<u>Punch-list Item</u>	<u>Punch-list Photo</u>	<u>Remedy for Signoff</u>
<p>Burlap and Wire Basket Visible (top 2/3 must be removed)</p>	 <p>Trees cannot be planted without having the top 2/3 of the burlap and wire removed. The burlap and wire basket should not be removed until the final placement of the tree has been set straight in the center of the pit, with the base of the trunk and the beginning of the roots known as the "trunk flare" level with the sidewalk grade. Locate the "trunk flare" by removing any excess soil within the burlap before placing the tree in the pit.</p>

Incorrect stakes/ties (8 ft Cedar stakes/ Arbor tie required)

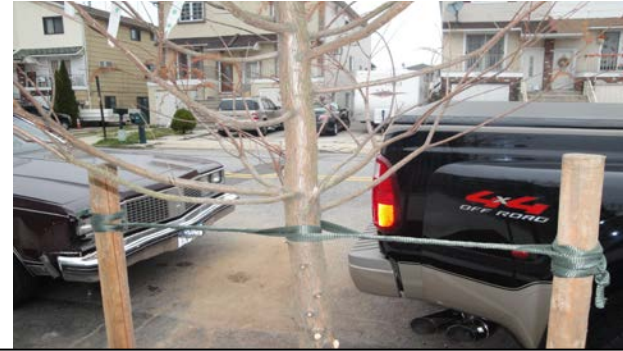
No metal wire to be used around trees! This will eventually kill the tree, through girdling.

Arbor tie and Cedar stakes will allow the tree to grow properly and should be removed at the end of the first year of the two year guarantee period.
